- 10 CFR 21 NOTIFICATION -
REPORTED INCIDENTS OF CERTAIN AECL-CP
TELETHERAPY UNITS

MEDICAL DEVICE RECALL ACTION
AECL-CP WARNING NOTICE WN-81-1

DIGITAL TREATMENT TIMER G7200 INSPECTION

Fig. 1. Location New Nameplate Label (Model A102409-654)

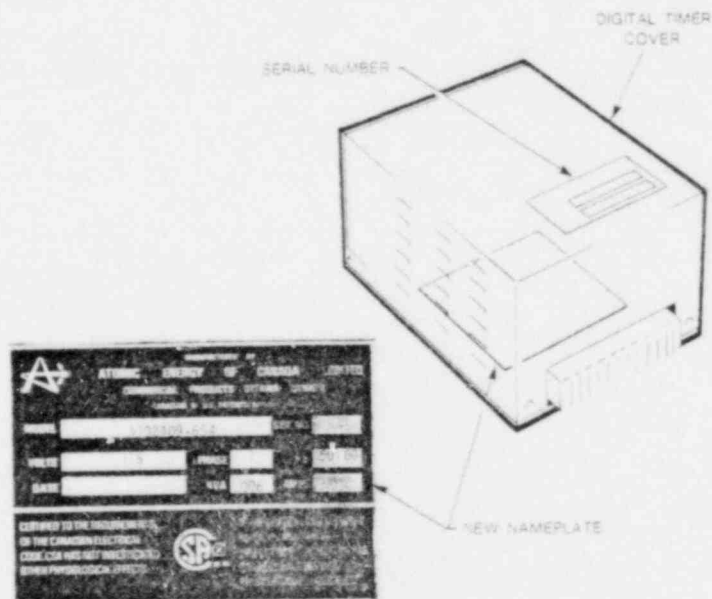
2. (i) On the Theratron 60 and 80 and the Eldorado 6 and 8, release the fastening screw near the top center, and pull out the front panel; it is hinged at the bottom.
(ii) On the Theratron 780 and Eldorado 78, remove the control console cover.
(iii) On the stand-alone model, remove the upper and lower outer covers.
3. The digital timer serial number is on the timer cover. Transfer the serial number to the new nameplate label (provided), Model A102409-654, and affix it to the underside of the timer. Ball-point pen or typewriter may be used for applying the serial number to the new label. See Fig. 1.

Fig. 2. Location of Nameplate Label (Model G7200) and Warning Label

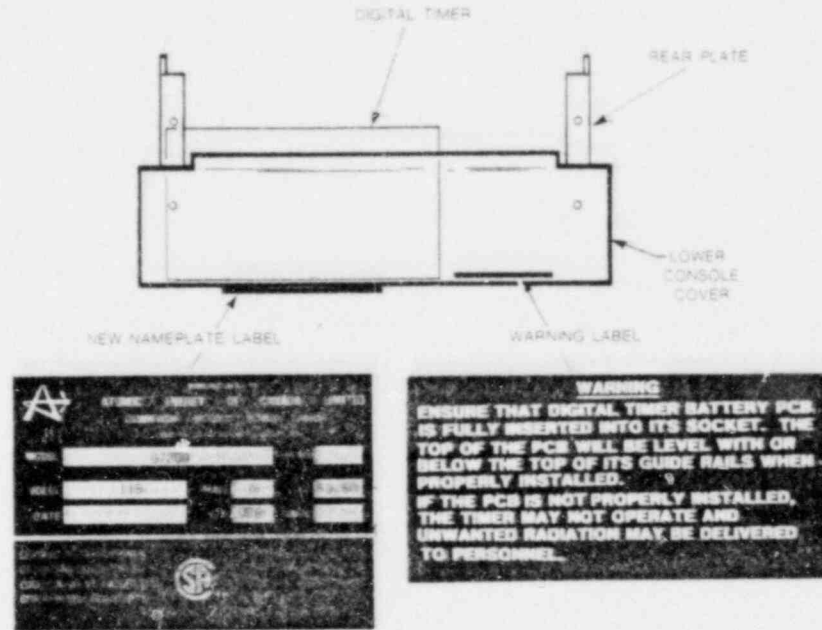
4. (i) On the stand-alone model, affix the new nameplate label, Model G7200, and the warning label (both provided) to the lower console cover. Do not affix to rear surface where they would interfere with the ventilation openings. See Fig. 2.

Fig. 3. Location of the Four Screws Retaining the Time Cover

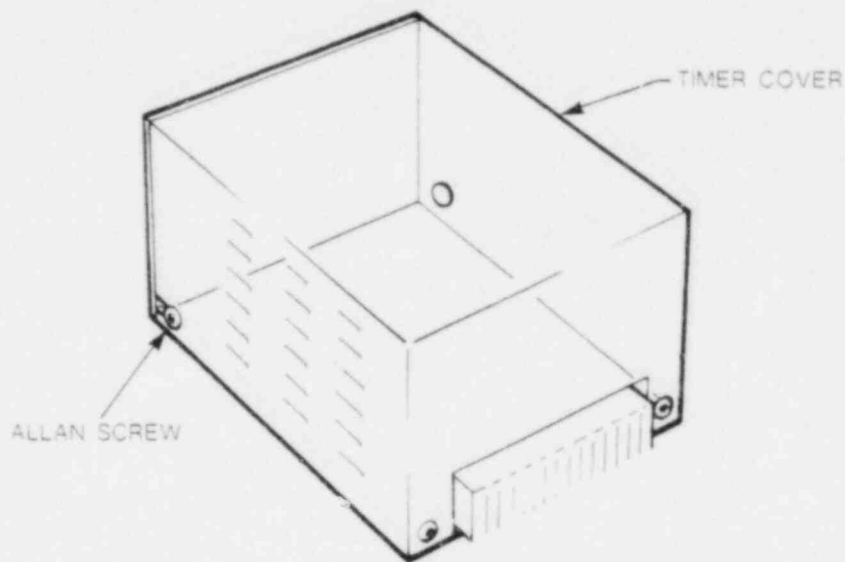
- (ii) On the Theratron 60, 80 and 780 and on the Eldorado 6, 8, and 78 console, affix the warning label (provided) to the exterior rear surface of the console. The new nameplate label, Model G7200, is not required.
5. Using the Allan key provided, remove and discard the four screws which retain the timer cover. Remove and discard the timer cover; DO NOT REINSTALL. See Fig. 3.
6. Ensure that the battery printed circuit board (PCB) is correctly installed; it must be fully inserted into its socket. The top of the PCB must be level with or below the top of its guide rails when properly installed.
